Kullman Consulting Services

RE: PLUS review – 2010-04-05; Montchanin Commercial Project

PLUS Comments

Figure 1: NRCS soil survey update in the immediate vicinity of the proposed project

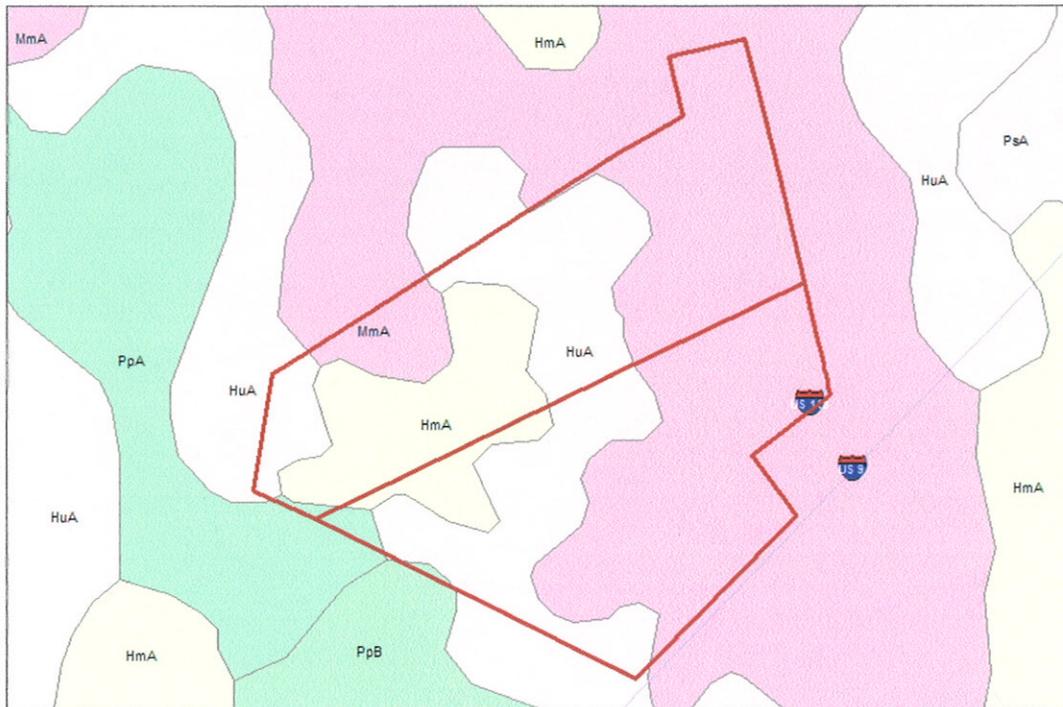
- DNREC strongly recommends that the applicant avoid soils mapped as Hurlock (HuA) and Mullica (MmA). These soils are poorly drained and indicative of wetland conditions (hydric). Building in such soils is likely to leave prospective residents of this and adjoining properties susceptible to future flooding problems from groundwater-driven surface water ponding, especially during extended periods of high-intensity rainfall events such as tropical storms/hurricanes or “nor’easters.” This is in addition to the increased probability of flooding due to or increased surface water runoff emanating from future created or constructed forms of structural imperviousness (e.g., rooftops, roads, parking areas, sidewalks, and stormwater management structures). Approximately 60-70% of the proposed project area contains Hurlock and Mullica soils (See figure 1).

The stormwater management design of this project will utilize Best Management Practices and will be reviewed and approved by the Sussex Conservation District. No off-site upstream or downstream flows will be affected by the development of this project.
